Single Electricity Market

DS3 System Services Technical Definitions

Decision Paper

SEM-13-098

Figure 2: Illustration of inertial response

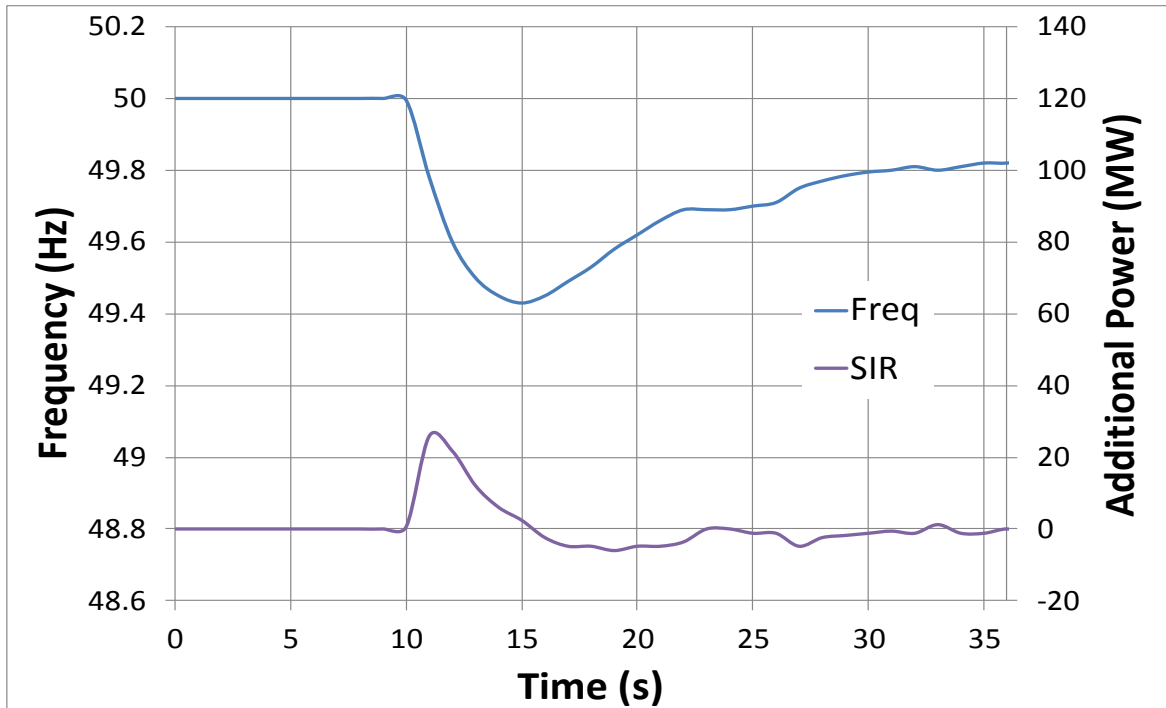
Respondents raised three main issues with the SIR definition: the 15 second threshold, the 45 second threshold and the exclusion of non-synchronised units such as flywheels from the definition. Respondents argued that the thresholds are not appropriate on the basis that all inertia has a value to the system. The lower threshold will therefore exclude some inertia

being provided but not rewarded and the upper threshold puts a limit on the value to providers of providing inertia at very low MW output. Furthermore, the requirement to be synchronised excludes some very fast response (but not instantaneous) technologies.

While the Committee accepts that there is a value to all inertia and that the inclusion of the 15 second threshold means that not all inertia provided to the system will be remunerated the Committee has decided that the 15 second threshold should be put in place. This excludes those units that cannot provide inertia at low MW output. The rationale for this is that the purpose of the new system services framework is that enhanced capability should be incentivised. As a matter of normal system operation a certain amount of inertia will be provided by synchronous generators. The Committee considers it would not be in consumers interests to pay for such inertia for two reasons. Firstly, such inertia would not provide adequate additional value for the consumer relative to the status quo and secondly such payments would weaken the economic signals to generators to provide enhanced capability. The overall System Services framework, including the service definitions must drive enhanced capability from providers and additional value to the consumer.

The 45 second threshold creates an upper limit on the SIR volume for which a provider will be remunerated. The Committee supports the existence of such an upper limit in principle as there is a limit on the value to the system of a single unit providing additional inertia beyond a certain point. Not to include an upper limit would result in a weakening of the economic signals to other units whose incremental additional inertia would provide more value to the consumer in terms of system resilience. The TSOs, on the basis of their own technical analysis, have advised that the suitable level of this upper limit is 45 seconds. The Committee accepts this analysis.

The Committee notes the concerns of some respondents in relation to the exclusion of some emerging technology (flywheels in particular), which is not synchronised, from this definition. However, the Committee notes that emerging technology is eligible provided it is synchronised and accordingly not all such technology is necessarily excluded. A further consideration is that the value of the SIR product comes largely from the immediate response of the unit to an event and while de-synchronised units may be able to react quickly there will be a moment in time where an inertial response is required but not provided. It is for this reason that the Committee does not consider it appropriate to extend the definition of the SIR service as previously proposed to providers who are not synchronised. However, the Committee in recognising that there is a potential value to such synthetic inertia and while this is distinct from the SIR service in that it is not synchronous, the Committee considers there may be merit in exploring with the TSOs the potential of such a service.

Figure 3: Fast Frequency Response

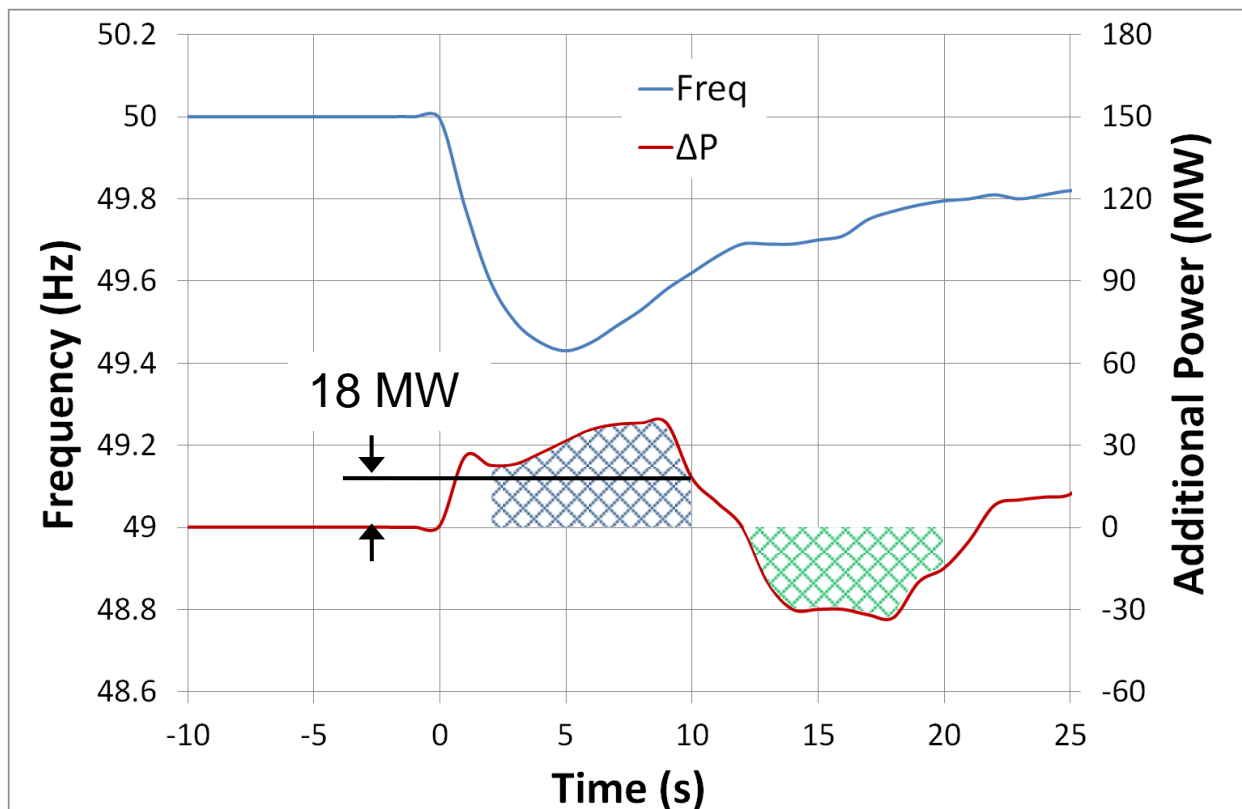
Several respondents had comments on FFR, mainly the comments supported some way of measuring the volume provided before two seconds. This issue is related to the issue discussed above in relation to SIR where non-synchronised providers are able to provide a response very quickly but not immediately. The view of respondents commenting on FFR was generally that there is a system value to providing as fast a response as possible and that incentivising providers to provide responses faster than two seconds would be beneficial to the system overall.

The Committee view is that while the purpose of System Services is to get more enhanced performance on the system it must be noted that this is not an end in itself. The purpose of enhanced performance is that it provides value to the end-consumer. Based on the TSOs'

technical analysis the system requires a FFR response within two seconds anything faster is over and above the required enhanced performance. Therefore, the Committee does not consider the FFR service should be defined to include responses faster than the TSO analysis suggests is required and the economic signals should accordingly focus on that standard as redistributing revenue from slower to faster FFR providers may result in less providers overall (as providers at or close to the two second threshold do not provide the service) and/or higher costs to the end-consumer than is justified by the value provided by the FFR service.

Figure 6: Illustration of the Q/P ranges for the SRP service

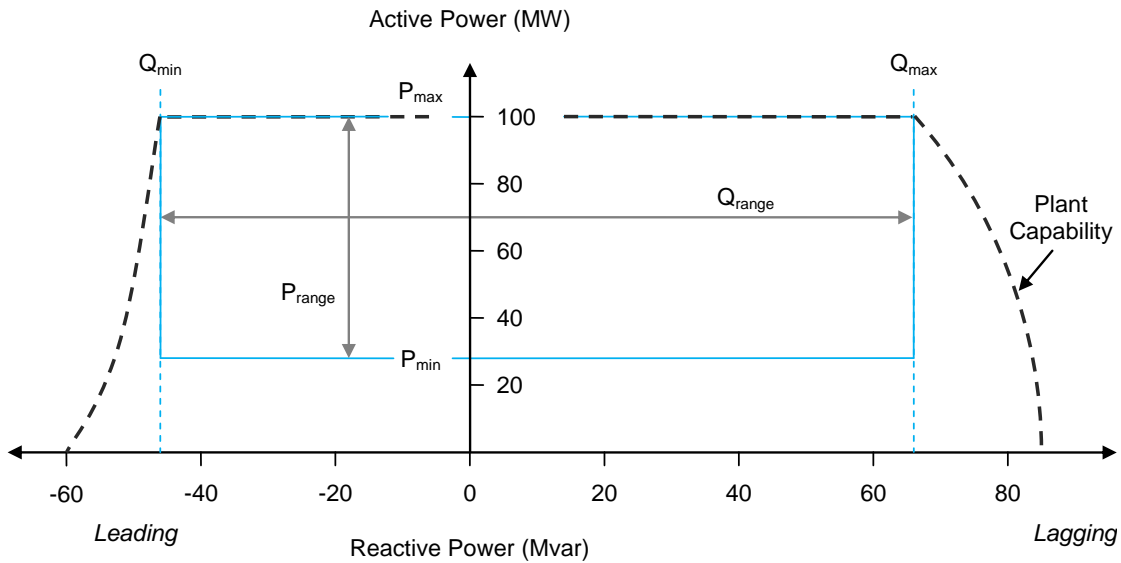
Several respondents raised issues with this definition. Some respondents were of the view that the requirement to require reactive power across the active power range was not appropriate on the basis that it excluded some providers who could provide reactive power at low active power output but could only provide less reactive power at higher active power output. They were of the view that remuneration of this service should reflect the full range of reactive power capability over its entire active power range. While some respondents raised this in relation to emerging technologies it is noted that this issue potentially applies to all types of unit. Another issue raised was in relation to the requirement for wind generators to maintain the reactive power range down to at least 12% of registered capacity. These respondents argue that all reactive power should be eligible for remuneration even if the unit is not able meet⁶ the minimum requirements put in place in February 2013.

The Committee notes respondents concerns with limiting the reactive power remunerated to that which can be maintained across the full range of active power (i.e. the area shown in

As noted above in relation to some of the other definitions the intent of System Services is to incentivise enhanced performance. This necessarily implies that the unit should at least meet the Grid Code standard and preferably exceed it. It is also noted that many of the wind farms applying for derogations have done so on the basis that meeting the new standards is excessively costly. It is open to such units to make the necessary investment in order to qualify to provide this service. However, having reviewed responses the Committee considers that Grid Code compliant providers should not be excluded from providing the SRP service and have accordingly modified the definition.

Figure 7) as opposed to the full range of reactive power over the entire active power range. The Committee does not consider it appropriate to remunerate reactive power which cannot be maintained across the active power range for two reasons. Firstly, such a provision would introduce a level of complexity in measuring a unit's volume that is potentially problematic in the context of implementing the overall system services framework. Secondly, and more importantly, because these providers could not be relied on to provide both reactive and active responses this would impose system operation costs (borne by consumers) but at lower investment costs for the provider, thus providing incentives that further increase system operation costs.
